Agenda Item	6.6
Report No	PLS-009-21

HIGHLAND COUNCIL

Report Title: 20/02155/FUL: Mr M. MacLeod
Riverbank, 22 Island Bank Road, Inverness IV2 4QS

Description: Alterations to house and formation of additional vehicular access

SITE PLAN - TREES

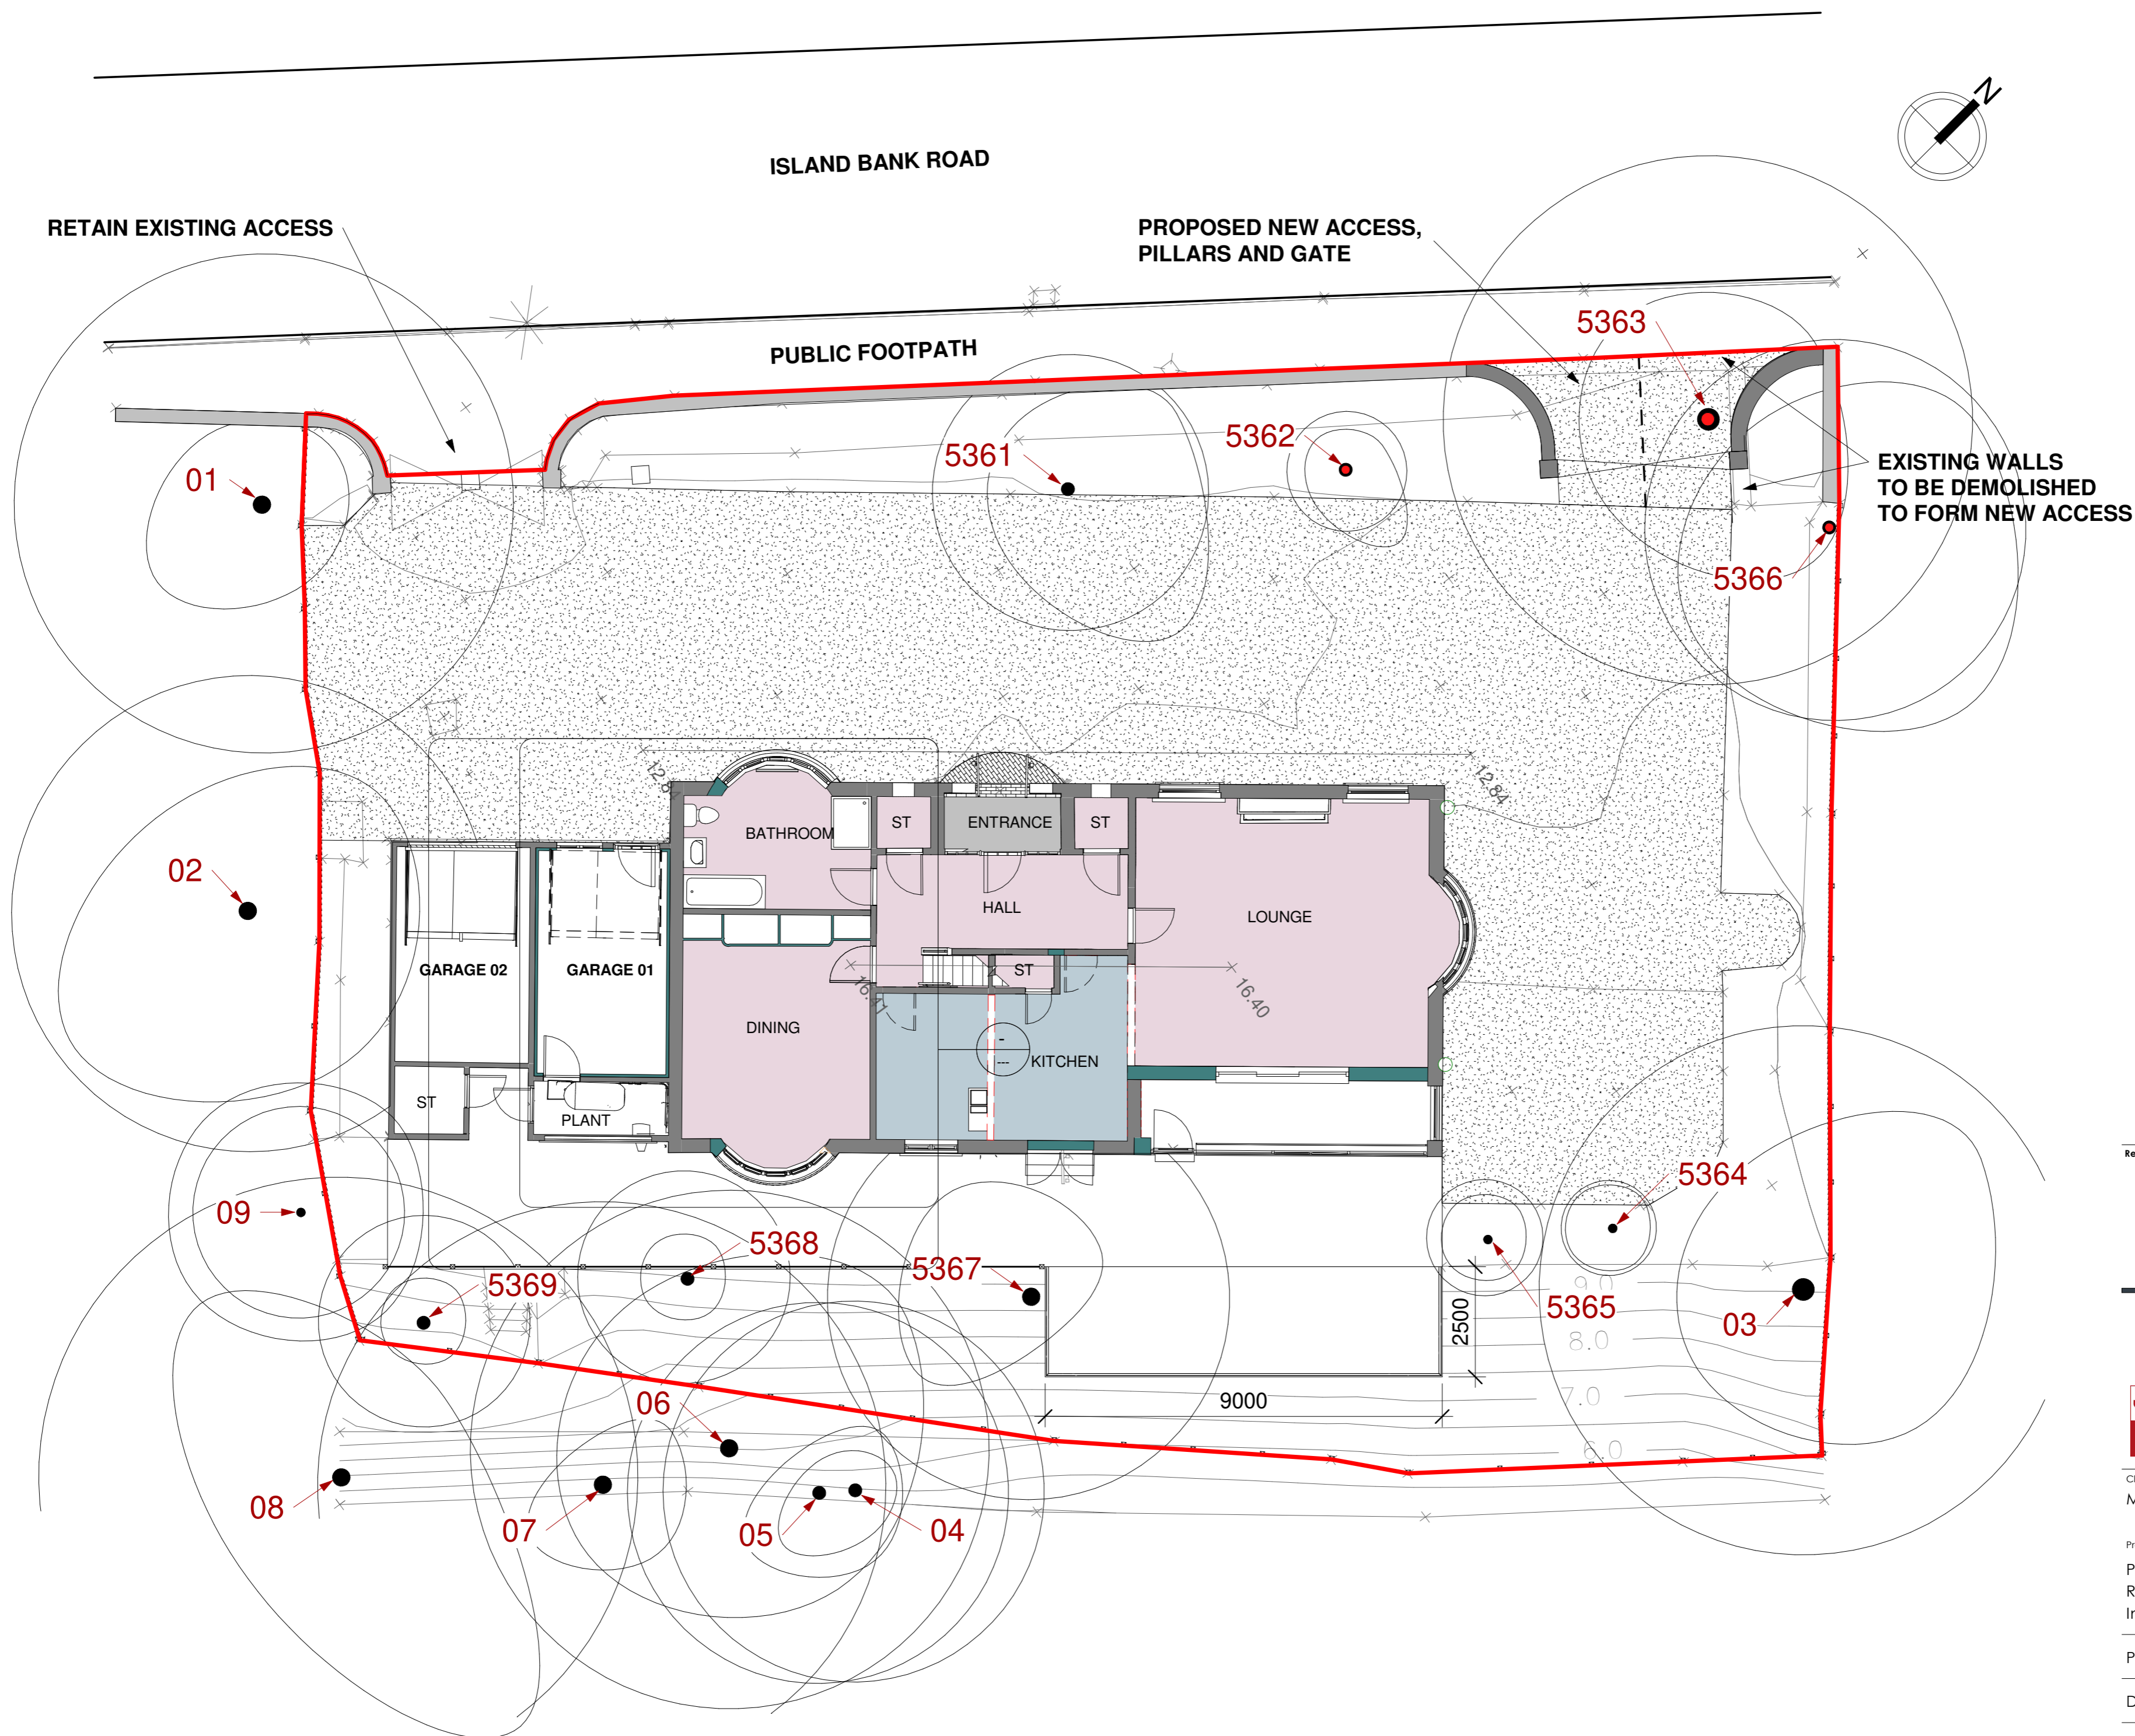
5.3 **Forestry Officer** supports the principle of these proposals, however indicates that "trees 7 & 8 cannot be consented for removal as they are outwith the red-line. A TPO tree work application would be required for the removal of these two trees. A further tree (5361) is recommended for re-pollarding and this is accepted. In addition, on the Site Plan - Tree drawing, the architect has proposed the removal of category 8 tree (5363) in order to form a new vehicular access. I would have no objection to the loss of this tree providing adequate replacement tree planting is provided. There are no tree protection plans in support of the application. These will be required, but on this occasion they could be required as a condition of consent. There are no tree planting proposals in support of the application. These will be required, but could be as a condition of consent. Conclusion: I have **no objections** to the proposed development, subject to the following conditions: -

- 8.10 Policy 51 Trees and Development notes that compensatory planting will be required for any removal. This has been noted by the Forestry Officer who has no objection to the removal of the large leylandii on the frontage, or other trees as noted, subject to a scheme of replacement planting being in-place and controlled by condition.

SITE PLAN
VISIBILITY SPLAY LAYOUT

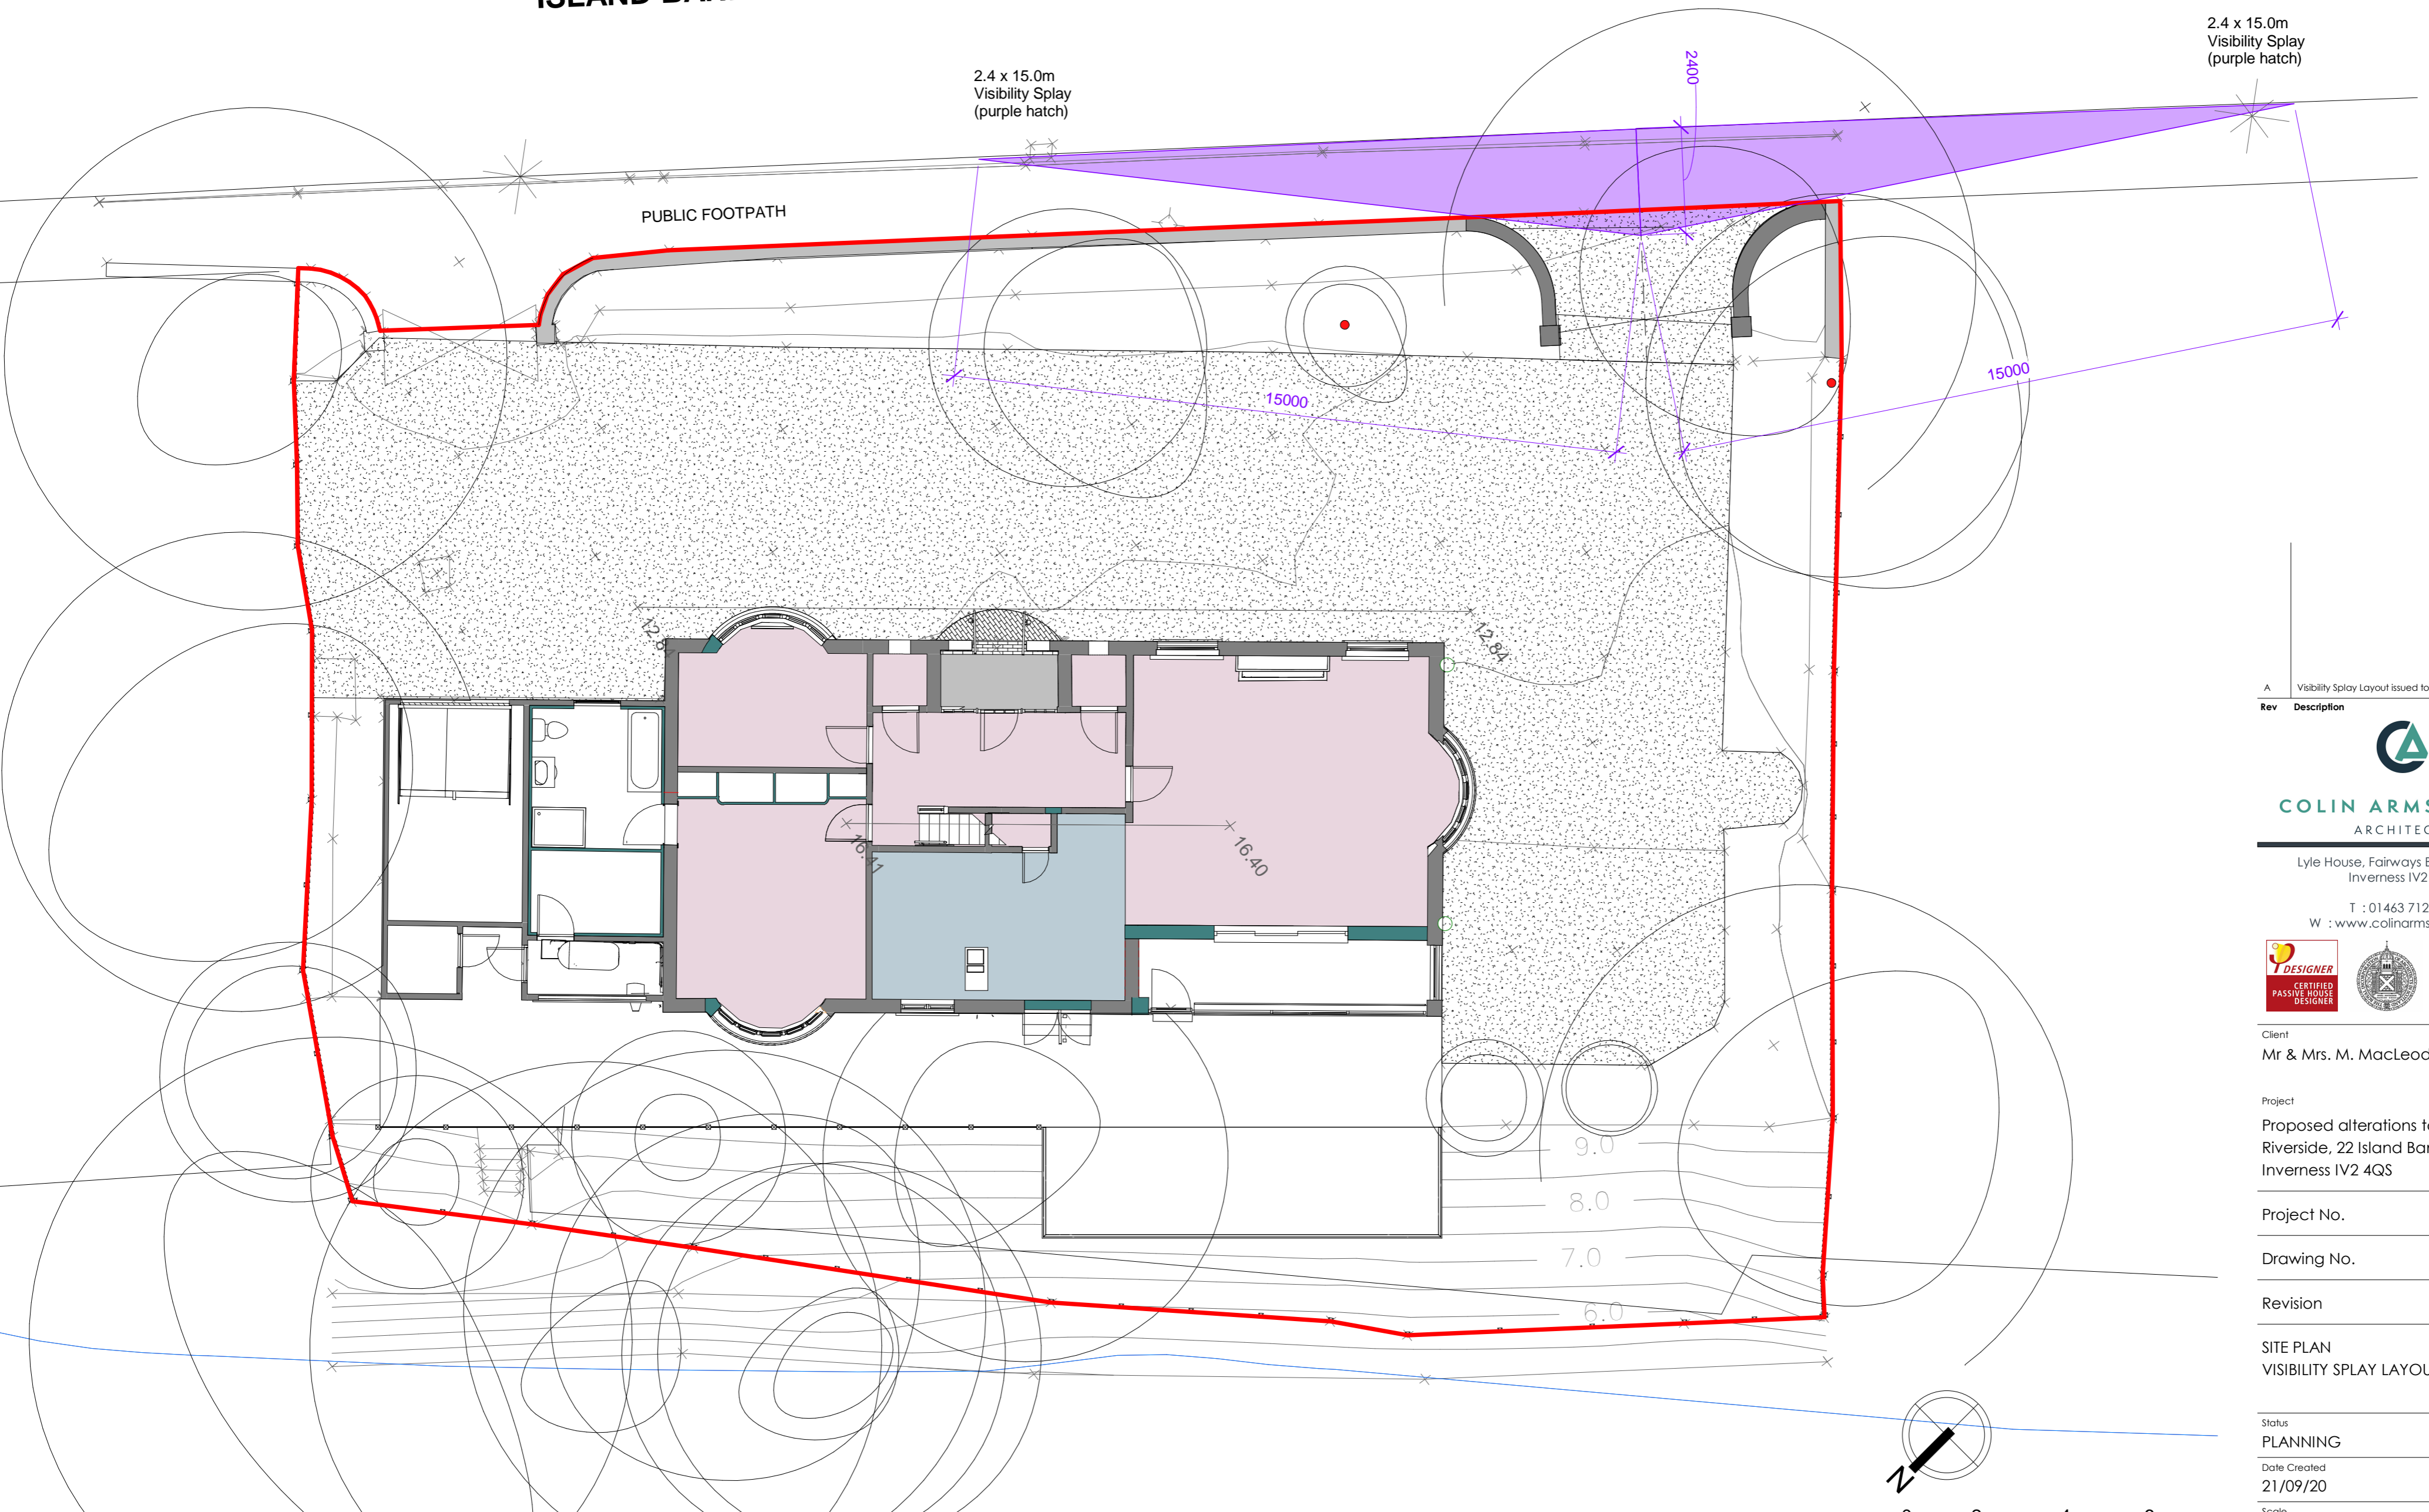
8.6 The agent has submitted a Private Access Checklist, as well as a plan indicating the visibility splays achievable by the proposed access; these indicate visibility splays of 15m, which are considerably below the required safety standard (of *at least* 45m) and to which Transport Planning has objected.

8.7 Visibility splays are measured from a point midway on a proposed access, 2.4m back from the edge of the carriageway, at a height of 1.05m (to replicate a typical driver's eye-line). It is worth noting that the 'Access to Single Houses and Small Housing Developments' guidance (adopted May 2011) requires a 90m visibility splay in each direction on a 30mph roadway. Table 5.3 in the 'Roads and Transport

Guidelines for New Developments' (May 2013) allows for 45/70m splays in a 30mph zone for minor/major residential streets; arguably Island Bank Road could be considered a major residential street, but Transport Planning has allowed the lower figure as it's a single-home access. The proposal does however fall far short of the minimum required safety standards.

1. The 15m visibility splays to the proposed new vehicular access are considerably below the Highland Council minimum standards and represent a serious risk to public safety, both to road users and pedestrians. The proposal would create a substandard access onto the Island Bank Road and fails to comply with the Roads and Transport Guidelines for New Developments' (May 2013) for the formation of the access meeting required visibility splays. The proposal would have an adverse impact on the safety and flow of traffic, and safety of pedestrians, on the local road network, contrary to policies 28 and 56 of the Highland-wide Local Development Plan, 2012.

3D Render - Balcony

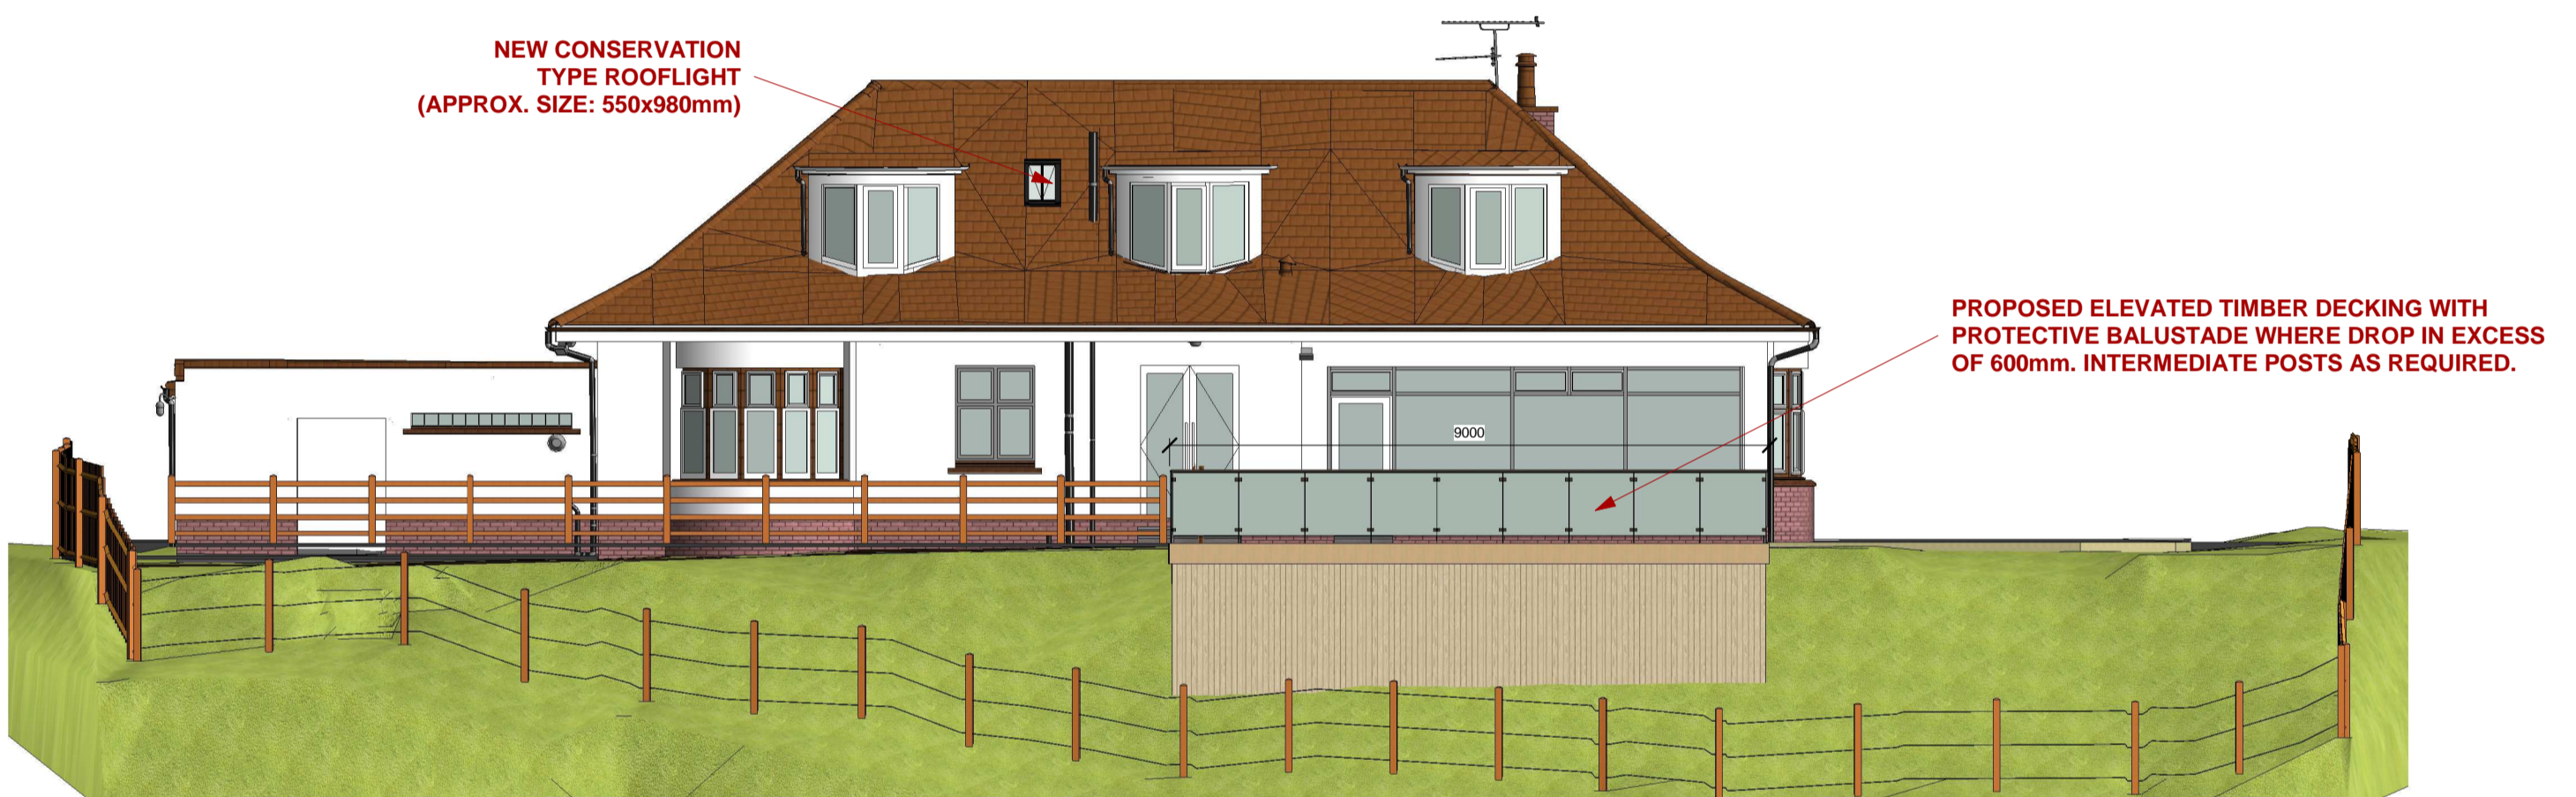
5.2 **Historic Environment Team:** "My only concern with the proposal is the expanse of horizontal timber cladding supporting the raised deck, and how visible this may be from the Ness Islands. Efforts to soften/break up the cladded area would be advisable through a suitably recessive painted finish and/or planting a series of shrubs, climbers or small trees at the base. Otherwise, in conservation terms the application can be **supported**."

- 8.9 The external design elements of this proposal are three-fold: the new vehicular access; the infilled garage-door/window, and; the rear deck. In theory the new vehicular access can be formed with walls and gates to match the existing, so aesthetically it need not be an issue. Infilling the garage doorway with a window and rendered wall to match would also be acceptable. The proposed upvc window is however unacceptable within a conservation area. Policy 57 Natural, Built and Cultural Heritage requires that development must not have an unacceptable impact on the natural environment, amenity and the heritage resource. The Historic Environment Team has noted that the rear platform/deck is visible from Ness Islands and have requested that the platform be painted/stained in a dark colour to make it less visible, which could be conditioned.
